ADDENDUM NO. 2

Bid Number 21-04-20

Jacobs Project No.: D3282100

Antioch Road Elevated Water Storage Tank

DATE	MARCH 2021
PROJ	D3282100
DWG	C-03
SHEET	12 of 21

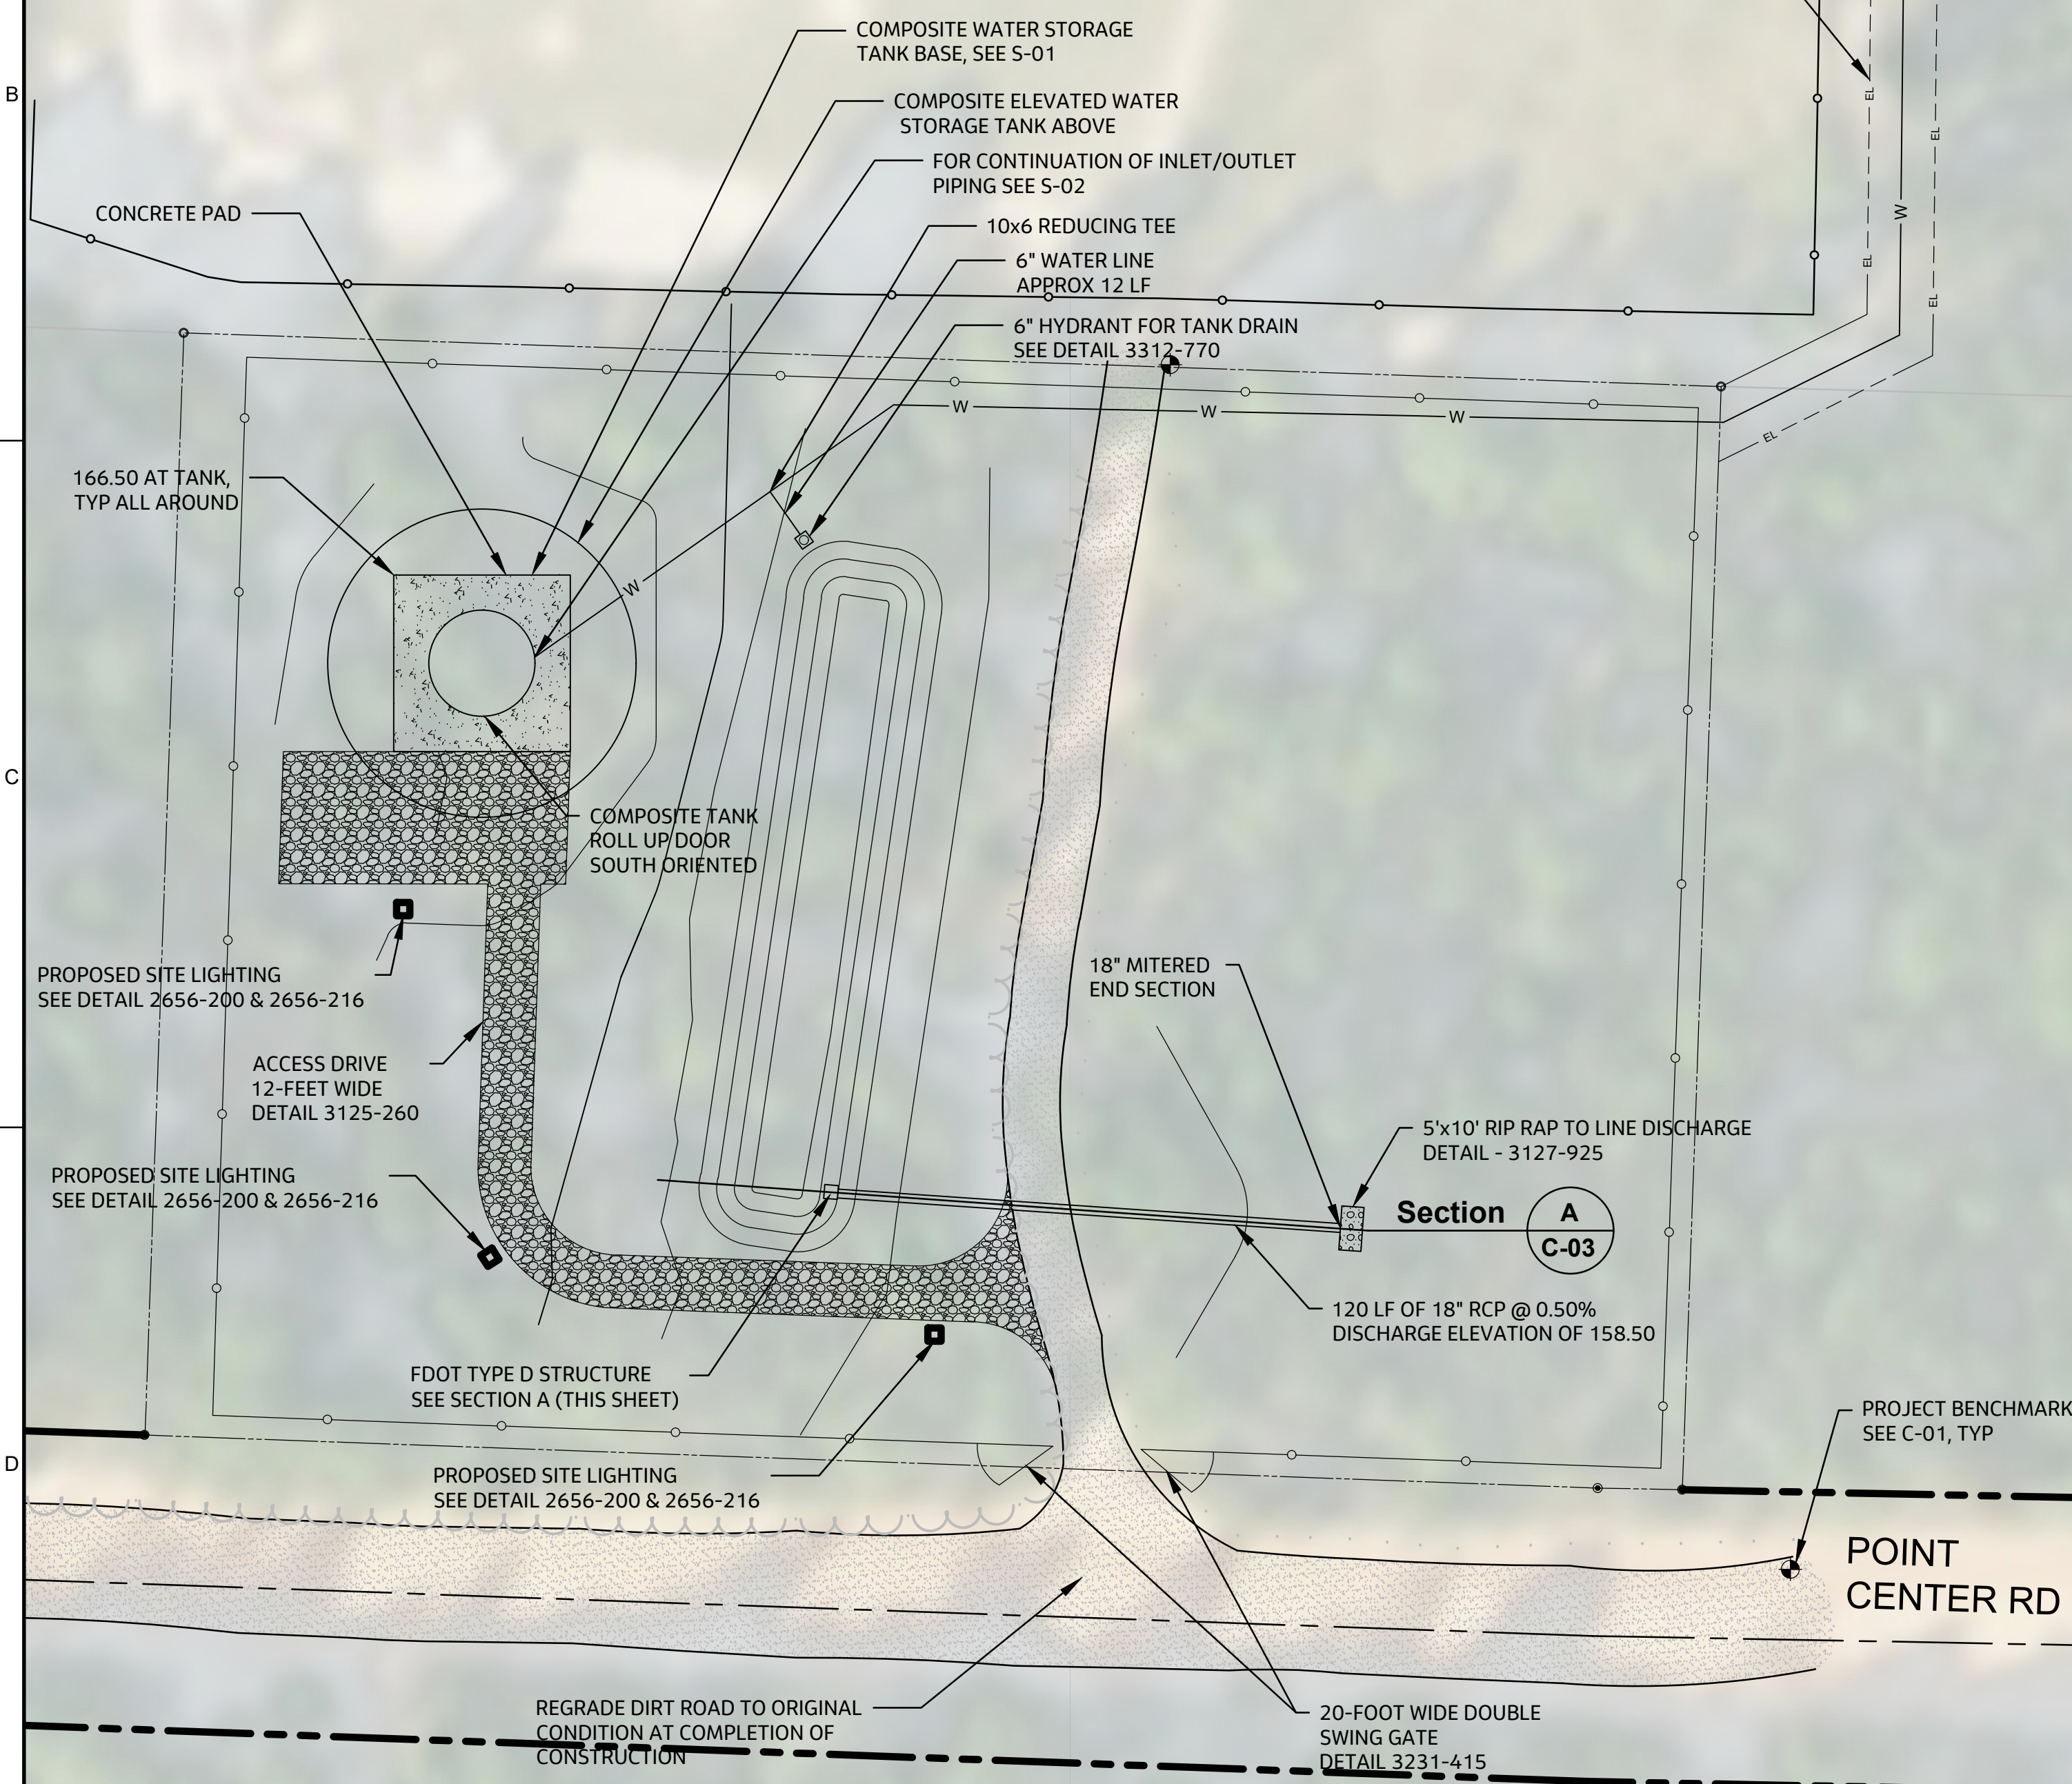
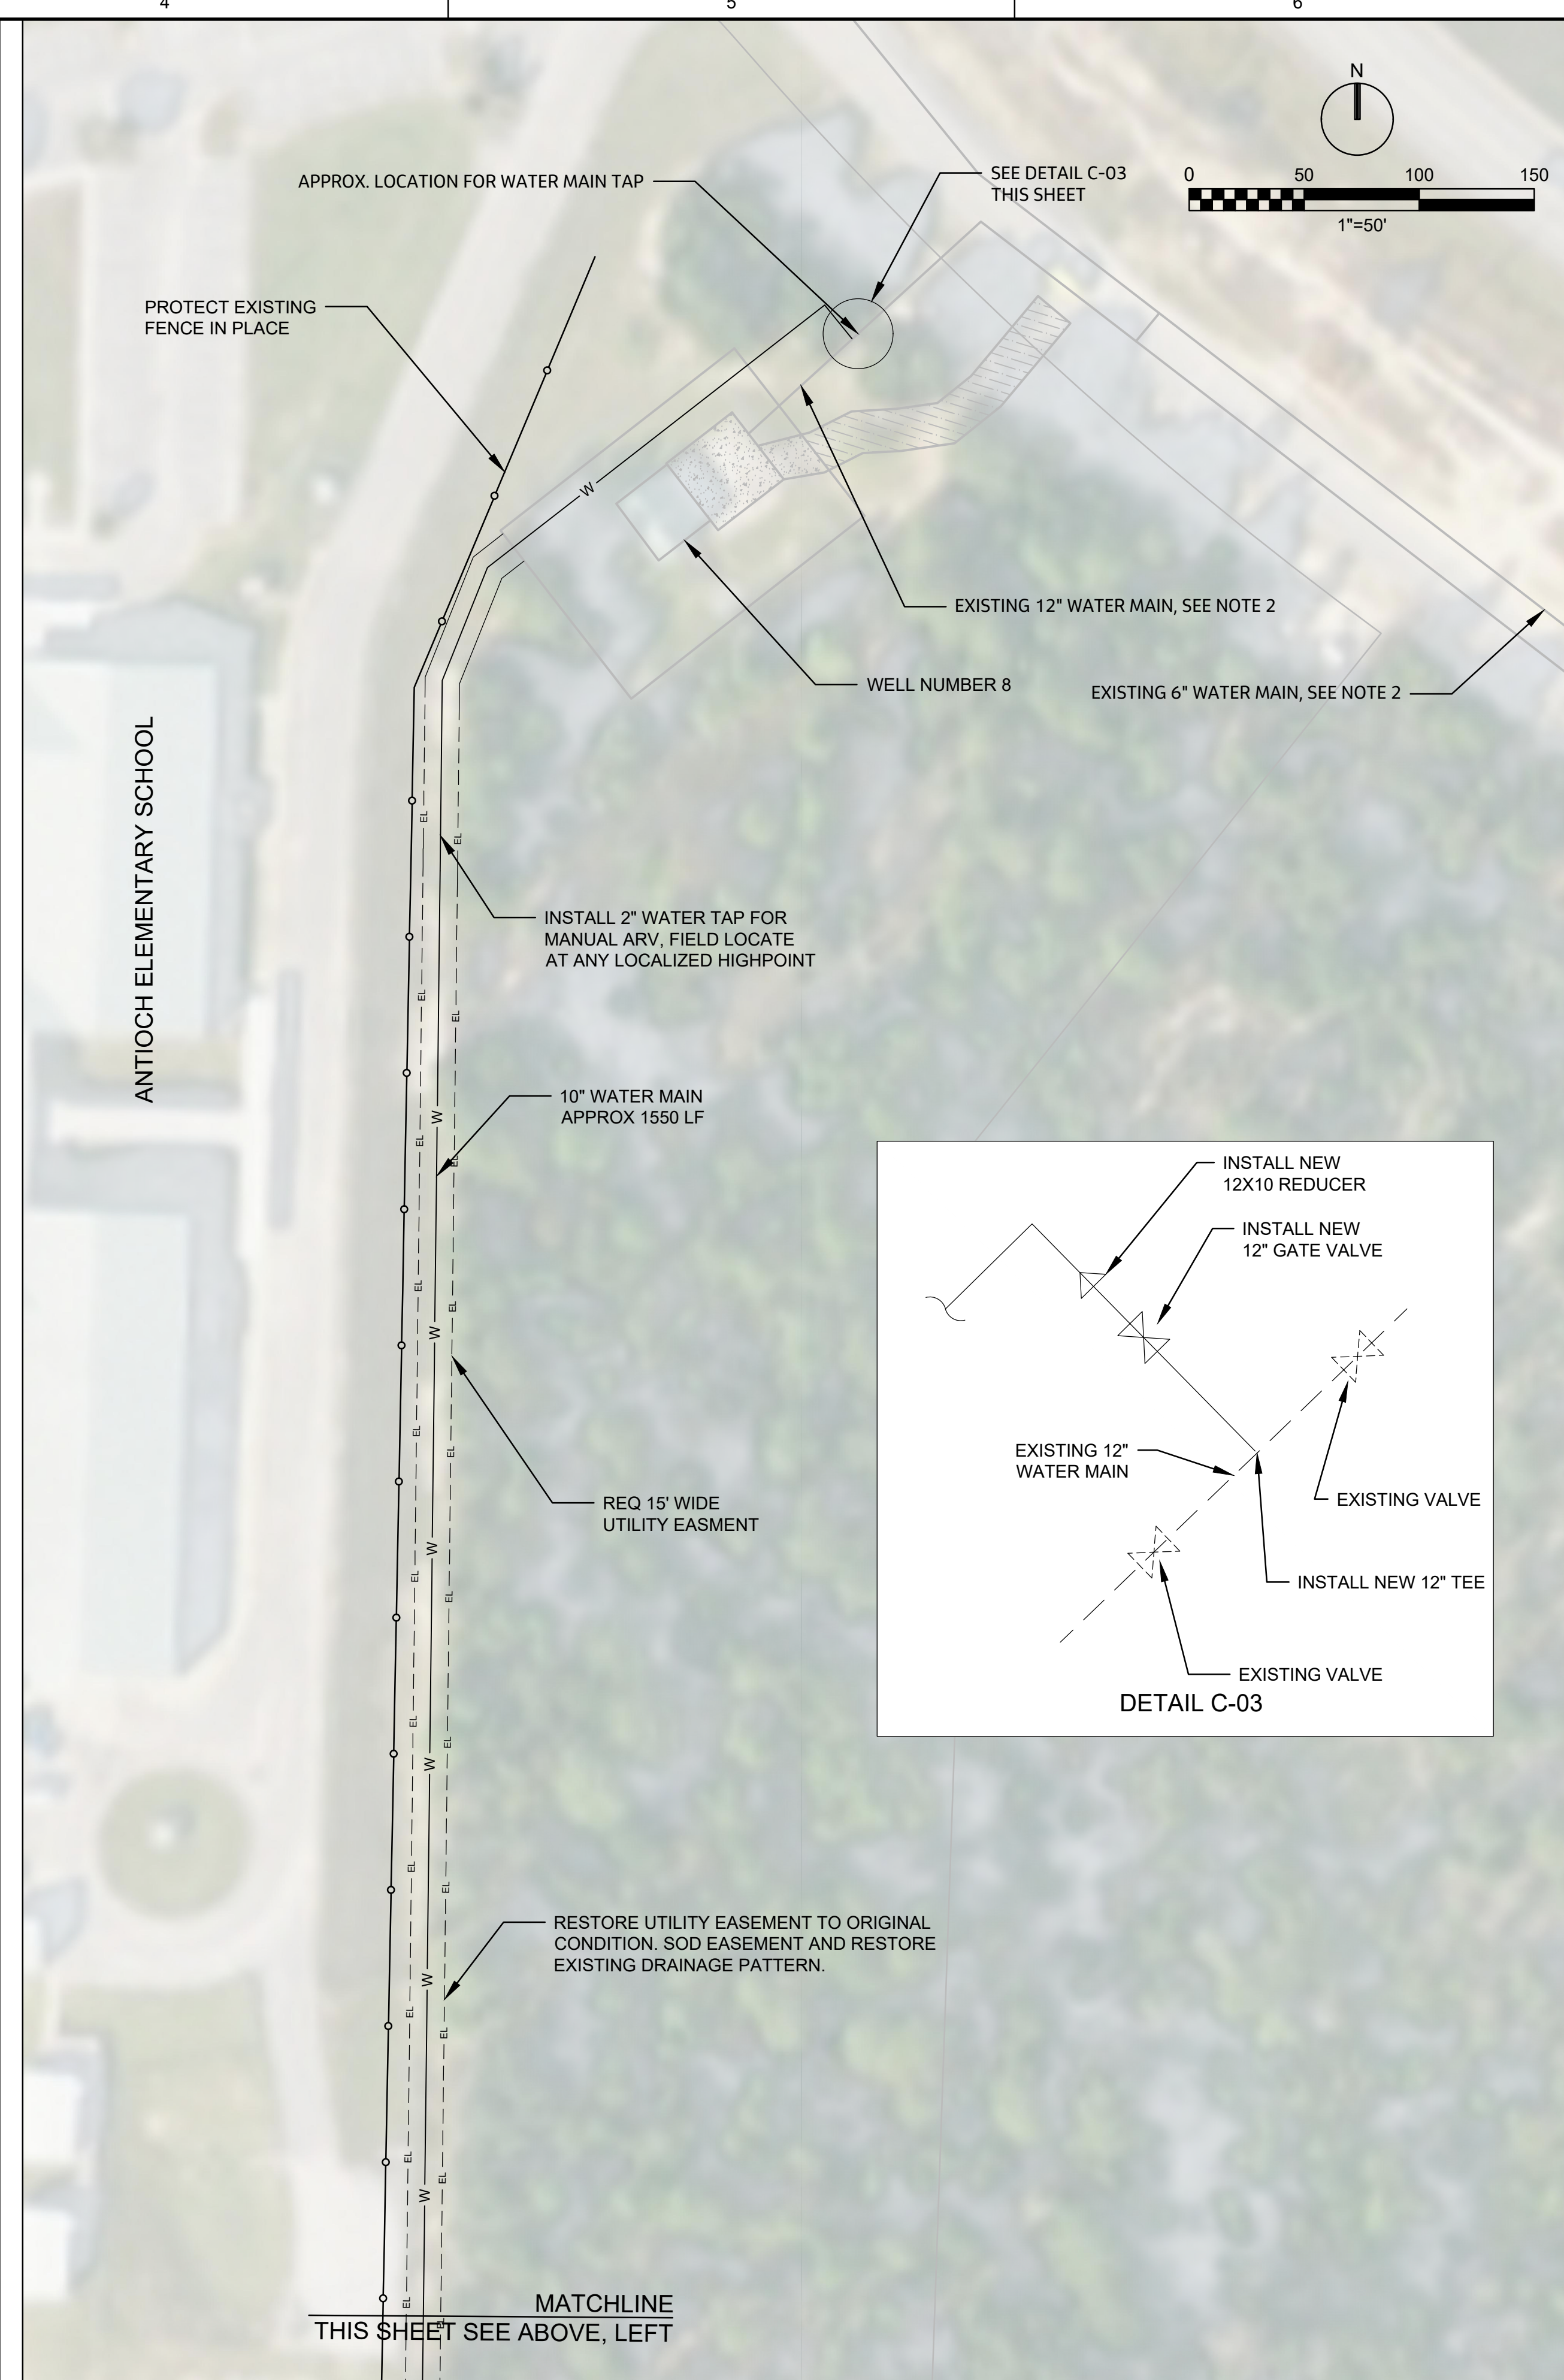
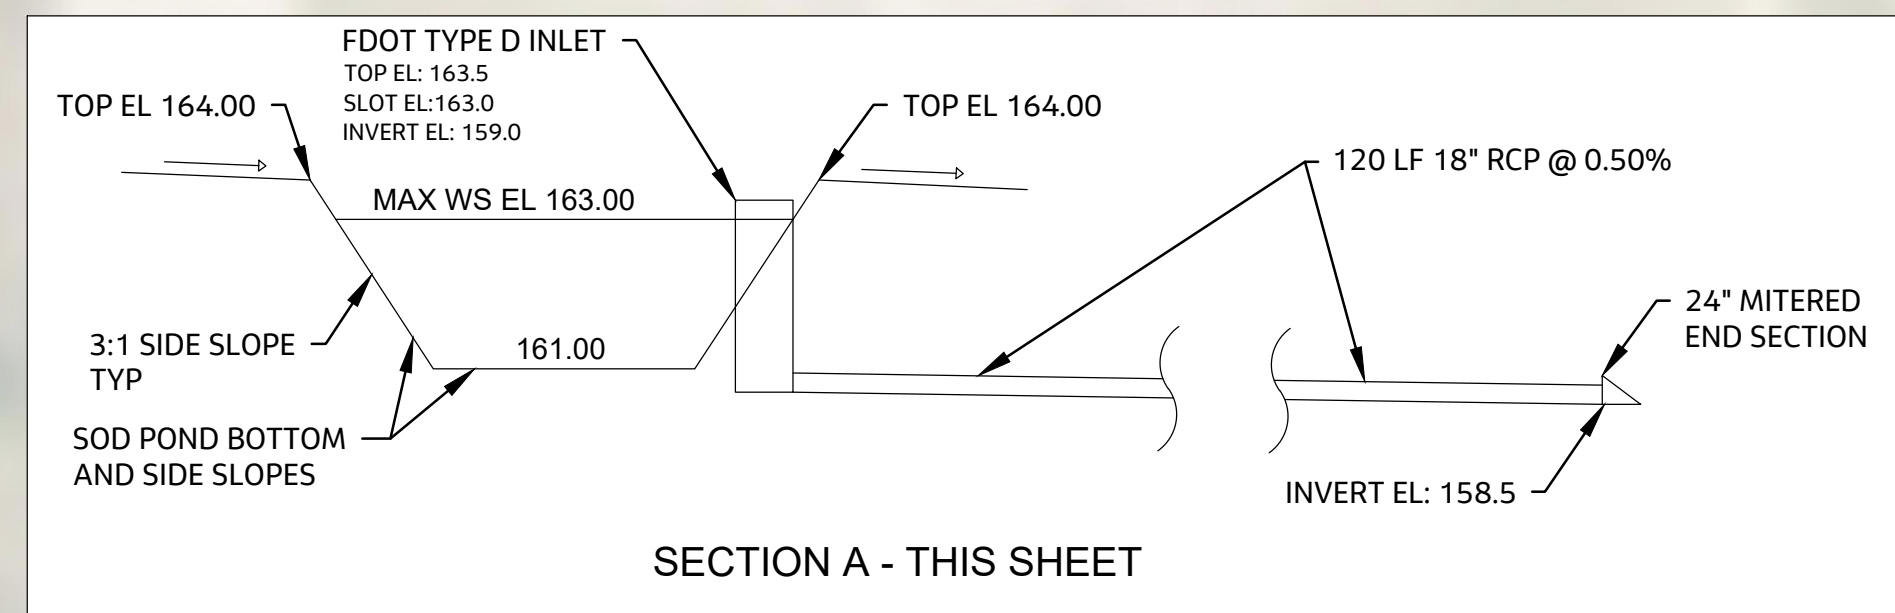
1. Sheet C-03 is hereby modified and reissued. A slot has been added to the stormwater outfall structure and the water line route has been modified near Well 8.
2. Sheet C-04 is hereby modified and reissued. The water line route has been modified near Well 8.
3. Sheet GA-01 is hereby added to the bid documents. This sheet provides the general arrangement information for the water spheroid style tank.
